REMARKS

Drawing Objections

Amendments to the Drawings

FIG. 1

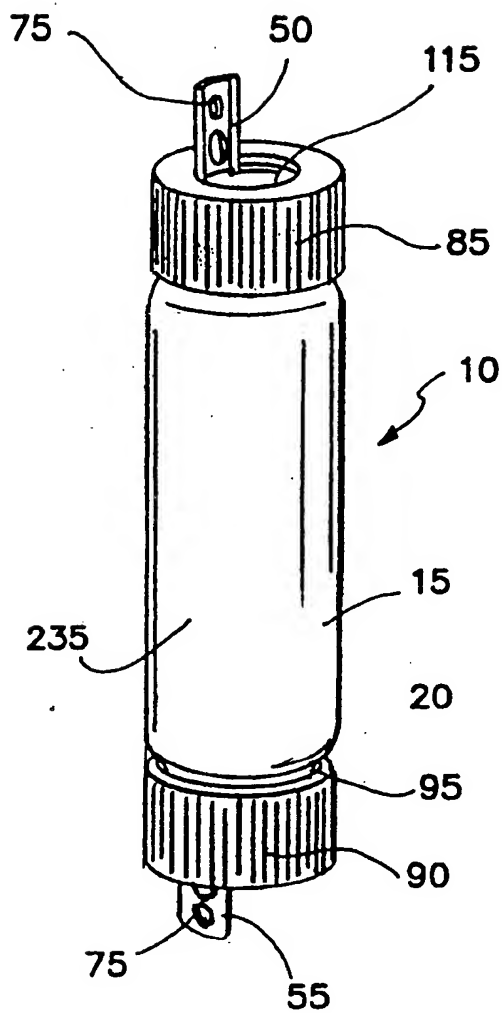
On p. 19, are "Figures 1,2,4,5 and 8" (line 10) a single embodiment? The written description in this manner suggests so, but the drawings certainly appear to be unrelated, let alone different.

While sample container **10** is shown in **Figure 5**, it is not readily visible. Line 10 of page 19 has been corrected to read "(1) **Figures 1, 2, 4, 6 and 8** illustrate a dual-opening sample container **10** that can be ..." Please see Amendments to the Specification on page 16, *supra*.

FIG. 2A

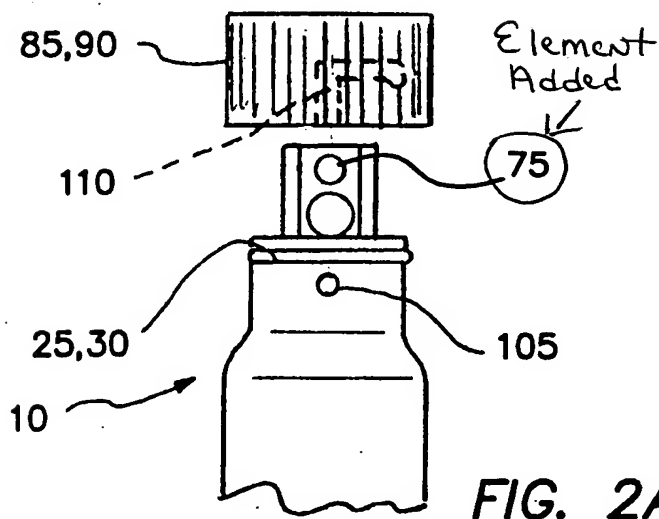
The Examining Attorney has objected to the drawings under 37 CFR 1.83(a), stating that the drawings must show every feature of the invention specified in the claims. "Therefore, the loops and hook (of claims 3,4,27,28), spring "outside" (claims 6,30), "containers" (claim 51, line 2) the container must be shown or the feature(s) canceled from the claim(s). No new matter should be entered."

Applicant has amended **Figure 2A** and added new **Figures 2B** and **2C**, illustrating the loops and hooks claimed. Please see attached "Replacement Sheets and Annotated Sheets Showing Changes." The issues relating to the spring "outside" and container have been addressed in the Amendment to the Drawings Section above.

The attached Replacement Sheet of drawings includes changes to **Figure 2A**. The new drawing sheet includes **Figures 2B** and **2C**. The Replacement Sheet, which includes **Figures 1, 2, and 2A**, replaces the original sheet which included **Figures 1, 2, and 2A**. In **Figure 2A**, previously omitted element **75** has been added. Element **75** was previously shown in **Figures 1, 2, 4** and **11**. In new **Figures 2B** and **2C**, previously described but unlabeled elements **77** and **79** have been added. Support for these changes is found in Claims 3, 4, 27 and 28 and on page 20, lines 2 and 5 and on page 24, lines 4 and 6 (see Amendments to the Specification above). No new matter has been added.

Annotated Sheet Showing Changes to **Figure 2A**
